## Stormwater Pollution Prevention Plan Inspection Report

**Project Name and Location:** Blackwell

Weather: 64	<input type="checkbox"/> Cloudy <input checked="" type="checkbox"/> Sunny <input type="checkbox"/> Rain <input type="checkbox"/> Snowing/ Snow cover
Date of inspection: 6/9/25	
Inspectors Name: Jessica Ekster	
Type of Inspection: <input checked="" type="checkbox"/> Regular <input type="checkbox"/> Rain event <input type="checkbox"/> Other:	
Rain in last 24 hrs (inches): .11"	
Owner/Permittee: Griffin Riley	
Current Site Condition: Active

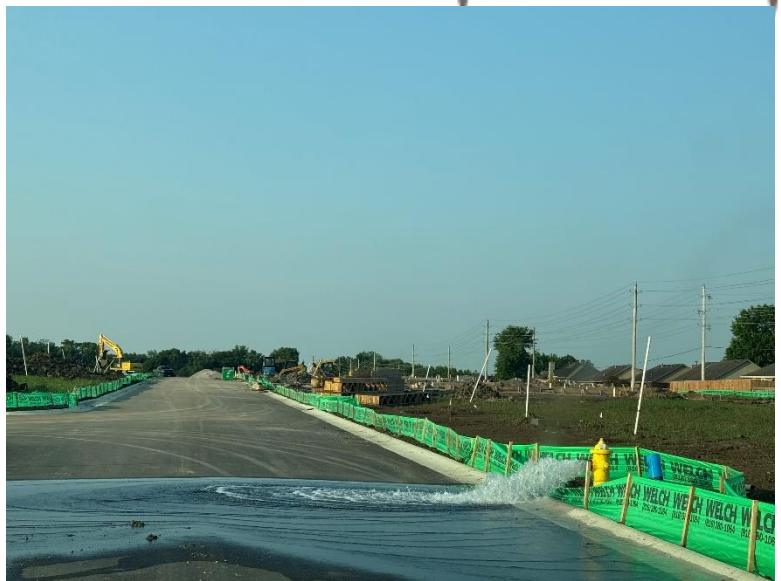
<b>BMP</b>	<b>Location</b>	<b>Observation, Effectiveness, &amp; Corrective Actions Ordered</b>
Silt fence	Along curb	Repair a few areas where the fence has been damaged- New areas
Stabilize	In-active	Stabilize all areas that have been inactive for 14+ days- Weeds are not considered vegetation.
Stabilize	Swale	Stabilize swale on North end as soon as possible if work is done- More silt build up near pond from swale needs cleaned out
Stabilize	Detention Ponds	Stabilize detention ponds asap- weeds are not considered vegetation
Silt fence	Detention Pond	Reset silt fence along detention pond behind Residences
Silt fence	Perimeter	Orange silt fence is not trenched in on East side of pond behind Residences- See picture below
